Circulate San Diego

January 11, 2017

RE: Complete Boulevard Study

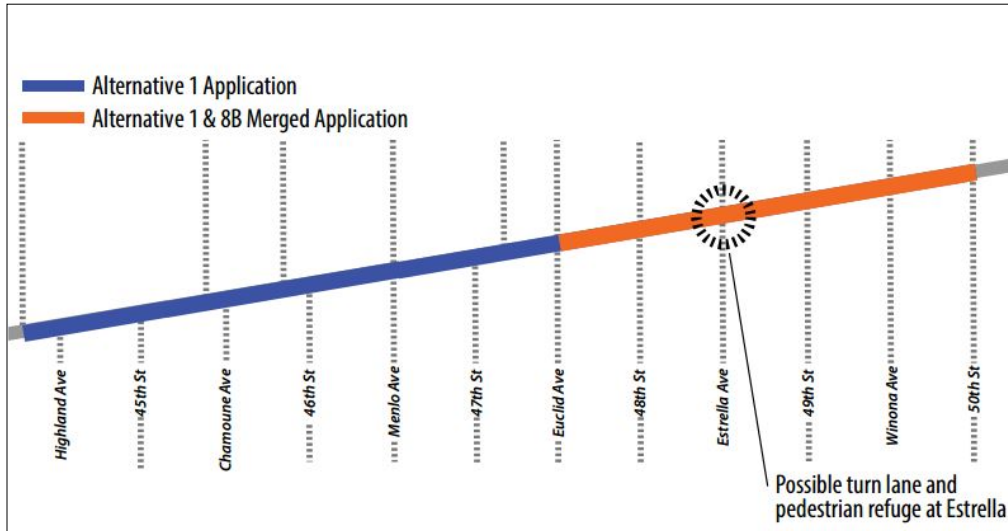
Circulate San Diego supports the improvements proposed in the Study to make walking safer along the corridor. These improvements include numerous curb extensions and new marked crosswalks. We also support the efforts to bring placeamking to the Little Saigon District through new monuments and cultural art. However, the proposed improvements exclude safe, connected bicycling facilities, and as a result will fail to reach the project’s stated goals. Further, the proposed improvements are incompatible with Vision Zero and Climate Action Plan goals adopted by the City of San Diego.

We at Circulate San Diego understand that achieving a balance of transportation modes is challenging, especially in urban built-out areas. The preferred Alternatives 1 Application, and 1 and 8b Merged Application (Preferred Alternative), improve pedestrian safety but put people who ride bicycles at risk for serious injury or death. We cannot support the Study as proposed. We do believe some of the alternatives studied are valid and urge the City to put these options back on the table for consideration.
